[Crandon Mine Project comments]. Volume 1 1982-1983

A copy of the Department of Natural Resources initial comments on Exxon's Mining Permit Application for the proposed Exxon/Crandon Mine is enclosed. The September 19, 1983 letter indicates general concerns, while the October 10, 1983 letter contains a more detailed response. Please place the enclosed information along with the other comments which are being kept with the Exxon Environmental Impact Report material.

September 19, 1983

1	9-83	CS	GENERAL	SCALE: NONE	STATE: WISCONSIN	COUNTY: FOREST	DATE: 1/29/72
REVISED	DATE	BY	DESCRIPTION	DATE	DATE	DATE	DATE
FIGURE 1.1-4							SHEET NO. 1

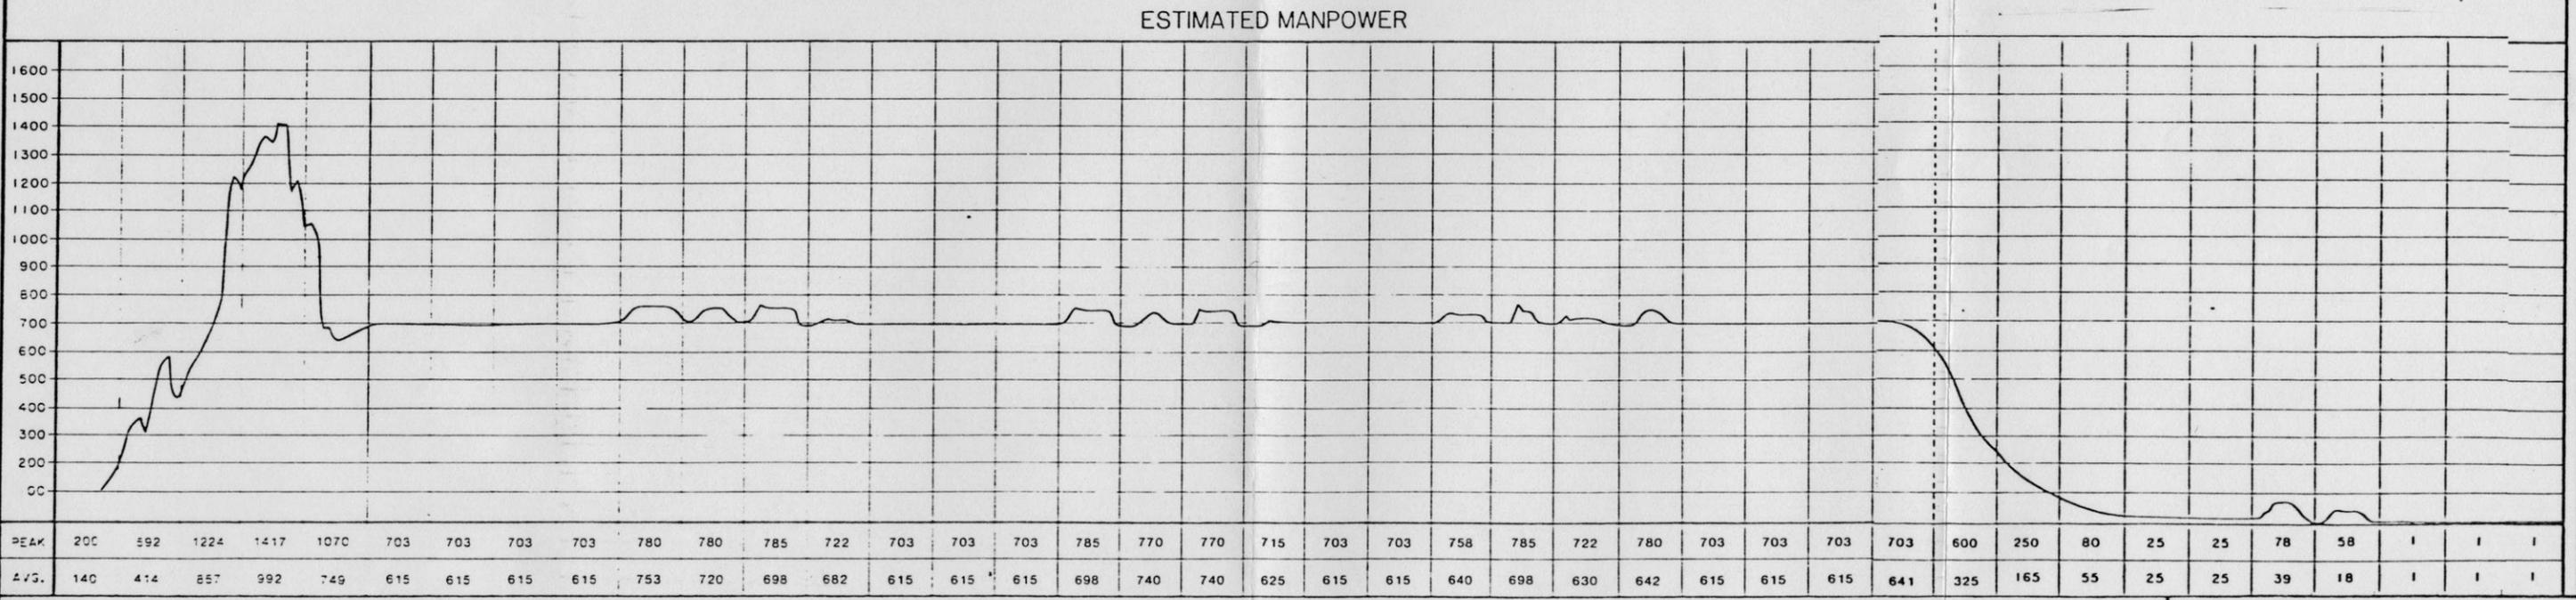
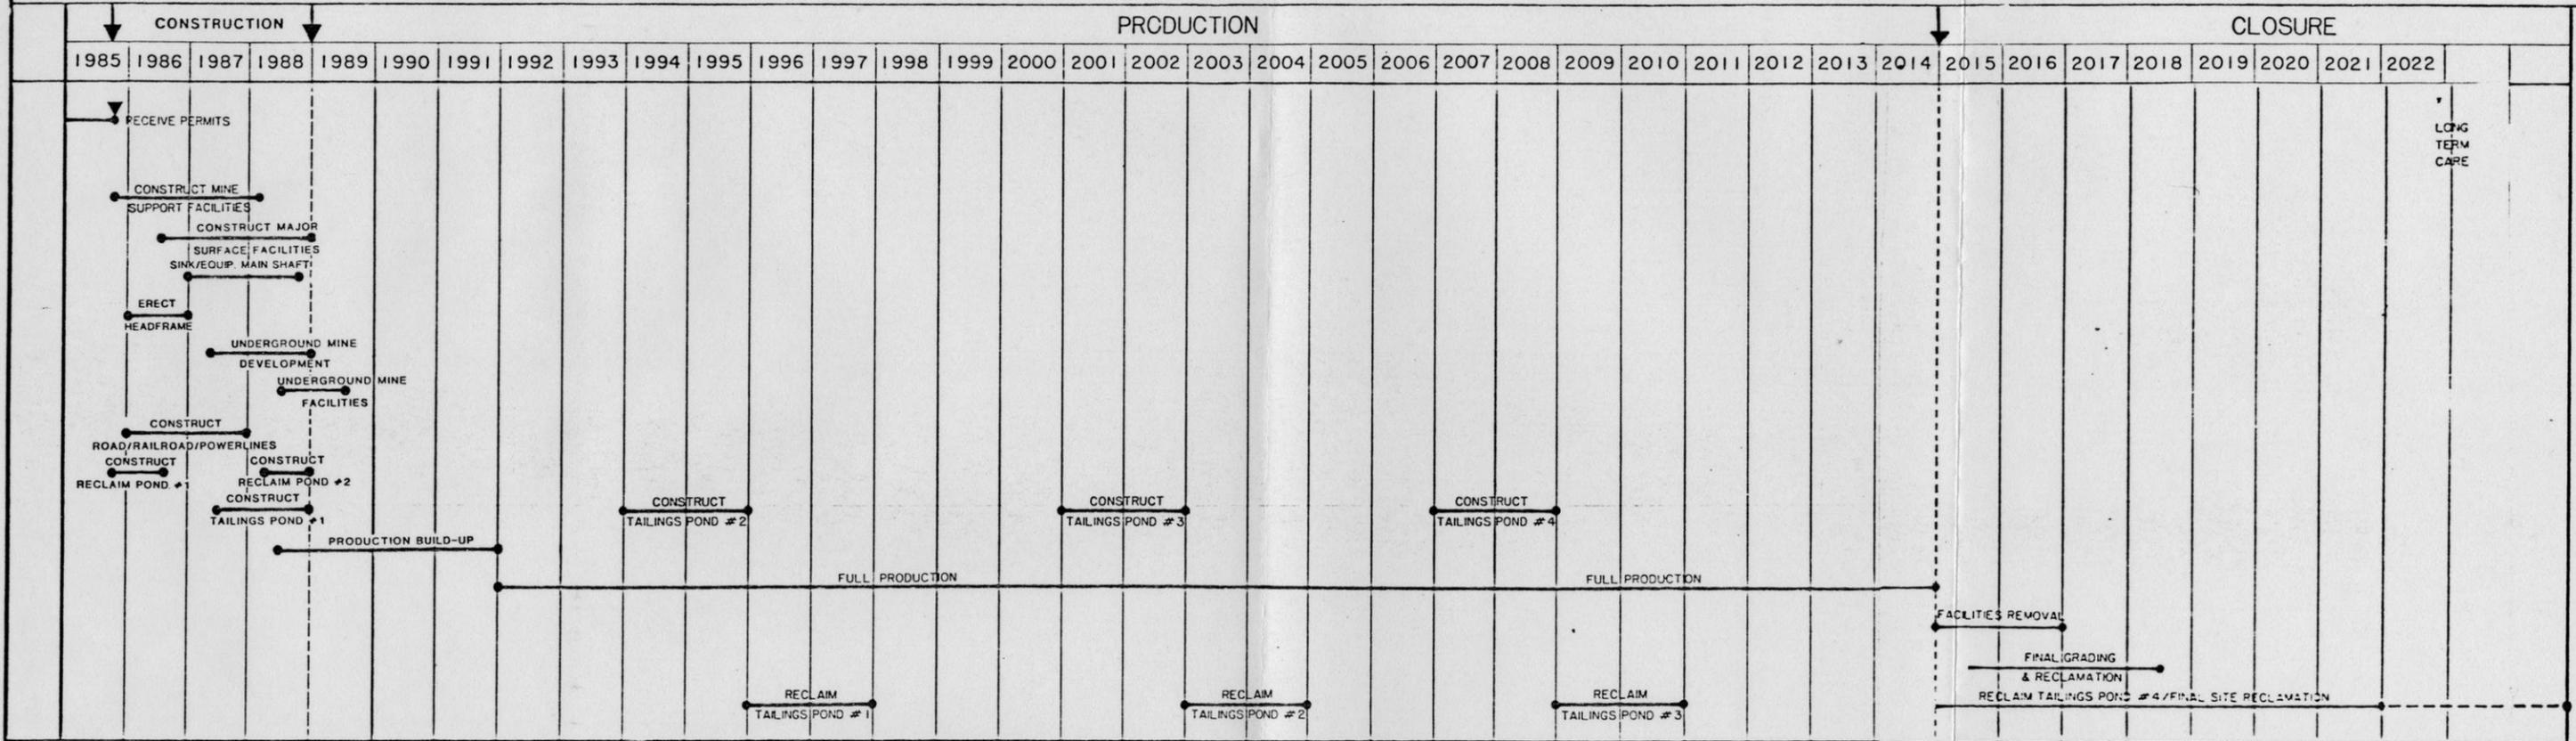
Figure 1.1-4 which indicates projected peak manpower requirements, must be supported by detailed employment needs by job category in Sections 1.3.3.1 and 1.4.2. Manpower requirements must be broken down by year, and must be accompanied by the assumptions and data used to derive the projections.

Exxon's new manpower projections consistent with the current execution philosophy are reflected in the attached Project schedule. Response to comments No. 30, 31, and 154 are based upon these new projections shown in Figures 1.1-4, Revision 1 (attached) and figures accompanying response to comment No. 154. The new information reflects current planning; however, it is subject to changes in their inherent dependency on market conditions, permitting factors, and Exxon's corporate decision process.

A condensed schedule for the Crandon Project is presented in Figure 1.1-4, Revision 1. This schedule illustrates schedule durations and interrelationships of major activities. The estimated manpower requirements required for each Project phase are presented, with further detail of employment needs given in subsections 1.3.3.1 and 1.4.2. Please refer to the response to comment No. 154 for these figures, the detailed manpower projections and the basis for development of these figures.

SCALE NONE	STATE WISCONSIN	COUNTY FOREST
DRAWN BY BWM	DATE 08-83	CHECKED BY C.D. ZERINGUE
APPROVED BY	DATE	APPROVED BY
APPROVED BY	DATE	EXXON
DRAWING NO FIGURE 154-1	SHEET OF	REVISION NO 1

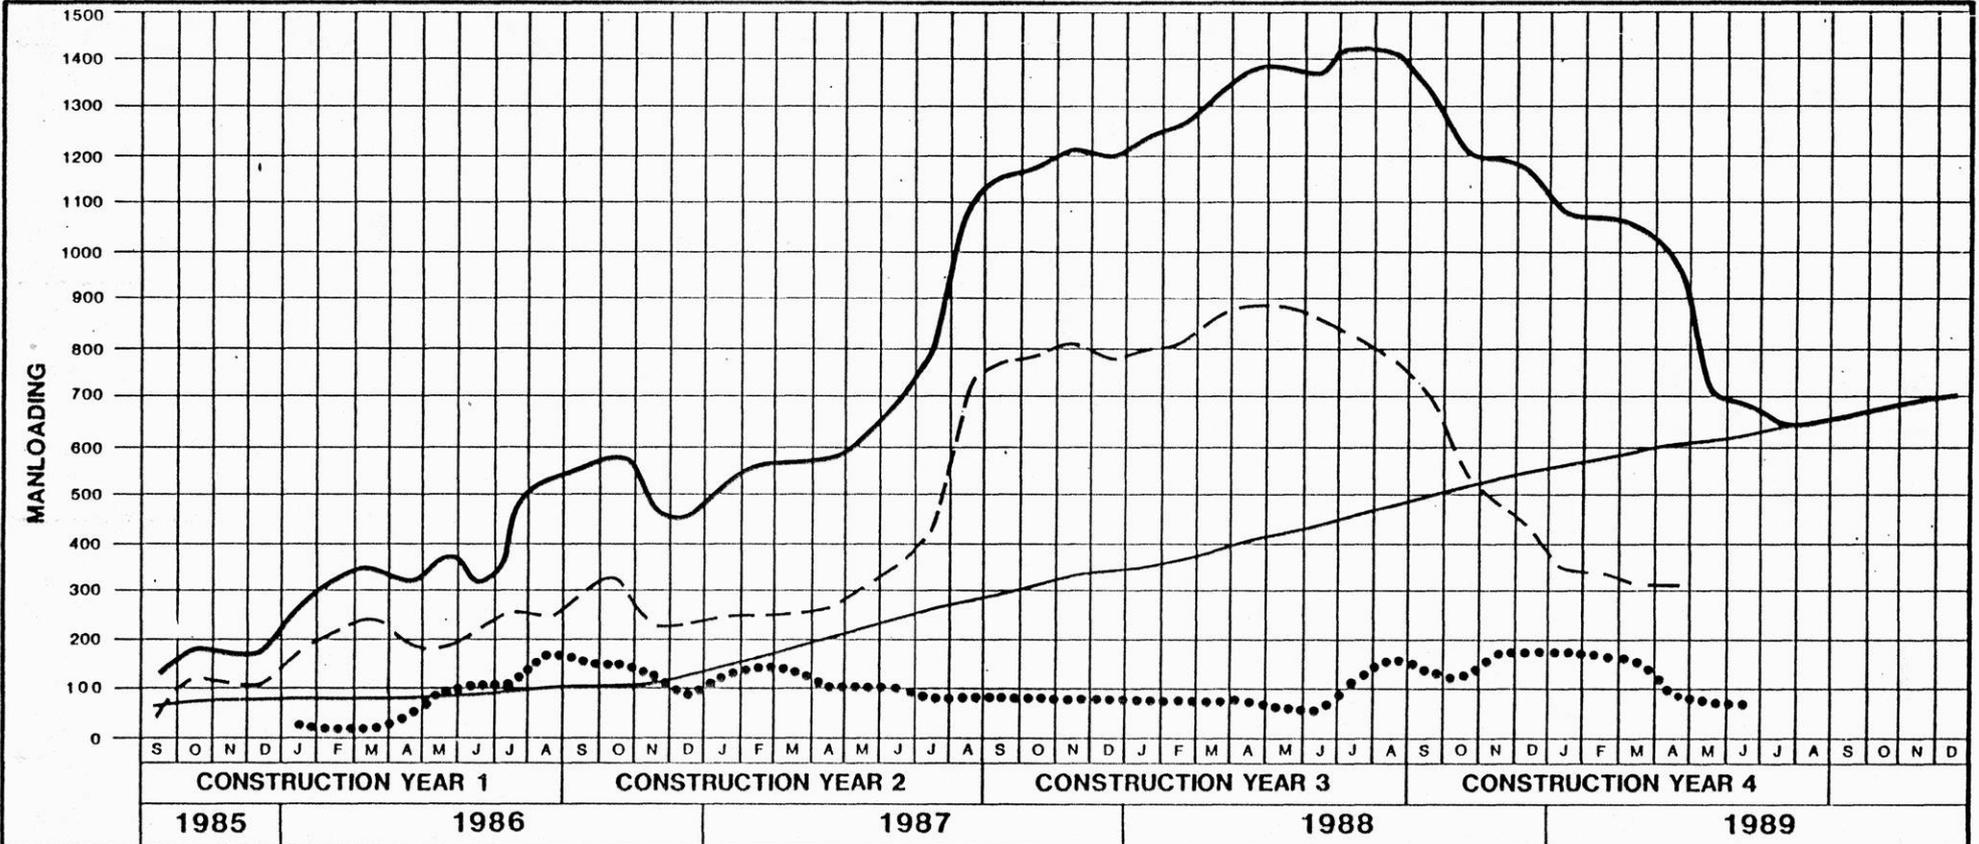
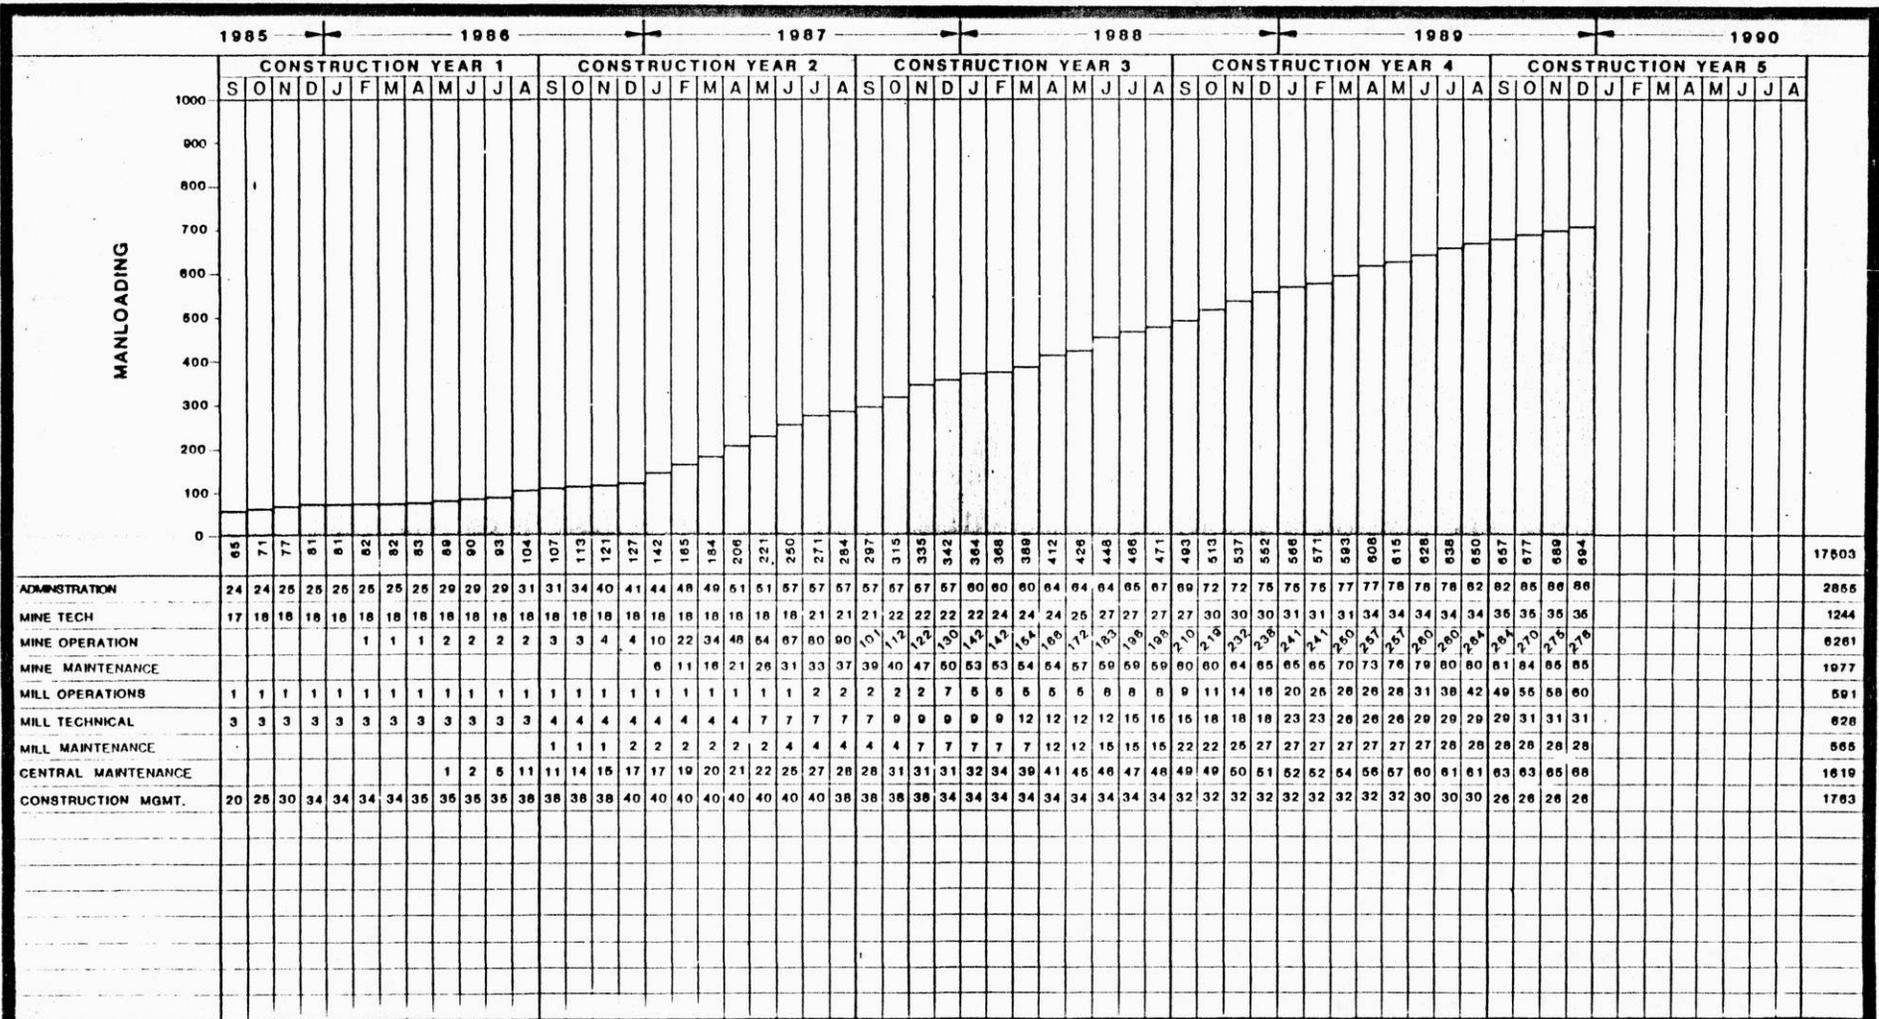
As previously indicated, projected manpower requirements must be accompanied by detailed employment needs by job category over the construction period. The data and assumptions used as a basis for Figure 1.3-15 are needed.

A composite curve illustrating total manpower requirements during construction and into the production phase is given in Figure 154-1 (attached). This curve depicts manpower requirements for three major areas: shaft and underground facilities, Exxon permanent employees, and surface facilities. Figure 154-2 (attached) presents the total manpower requirements for each area by month. Assumptions used for the development of each major area follows:

- 1) Contractor Construction Manpower - the detailed construction manpower requirements by craft for the shaft and underground facilities are shown on Figure 154-3 (attached). Activities include sinking the main and ventilation shafts, headframe erection, development of the rail haulage drift, and development of the underground crushing station including equipment installation. Manpower assessments were developed for each activity based upon contractor estimates for construction of the headframe, main shaft sinking, and intake air shaft sinking. These estimates evaluate crew sizes based upon shift requirements and schedule demands. The remainder of the activities are developed similarly through analysis of each construction task, determination of required equipment and materials, and development of crews for each task.

- 2) Exxon Permanent Employees (see Figure 154-4 [attached]). Exxon permanent employees who will be involved in operations, maintenance, and technical support for the mine and mill facilities are included in Figure 154-4. These personnel will be engaged in underground mine development work and prestart-up of the surface production facilities. They will also fulfill construction management requirements for administration of various contracts for surface and underground work prior to mine and mill start-up. During start-up many of these people will assume their permanent positions as operations, maintenance, and technical support staff. Positions were first identified on an overall Crandon Project organization chart. All positions were then staged through the construction phase, and into the production phase, to meet schedule demands for mine/mill start-up, construction management requirements, and reasonable rates for effective employee assimilation and training.
